# Technical Service Bulletin

<b>Subject:</b> <b>AIR CONDITIONER DOES NOT BLOW COLD AIR DUE TO CRACKED COOLER PIPE (HI) A (REFRIGERANT LEAK)</b>	<b>Bulletin No.:</b> 07-002/21
	<b>Last Issued:</b> 02/01/2021

(1)	Cooler pipe (HI) A
(2)	A/C compressor
(3)	Condenser

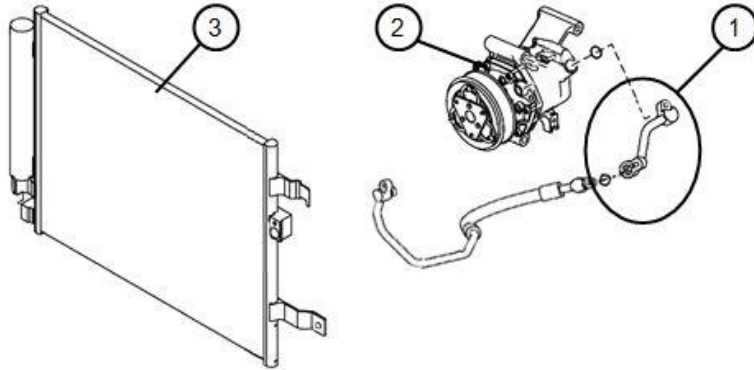
Some vehicles may experience that the A/C does not blow cold air (blows warm air) due to a refrigerant leak. This is caused by a crack in the cooler pipe (HI) A (1) due to engine vibration. To correct this issue, the material and thickness of the cooler pipe (HI) A has been changed to increase durability (pipe diameter has been changed from 12mm to 16mm).

Location of cracking

- If the cooler pipe (HI) A is cracked, replace the cooler pipe (HI) A with a modified one according to the instructions on MGSS (REFRIGERANT LINE REMOVAL/INSTALLATION).
- If the cooler pipe (HI) A is not cracked, this TSB is not applicable. Refer to troubleshooting procedure on MGSS (NO COOL AIR [CLIMATE CONTROL SYSTEM]).
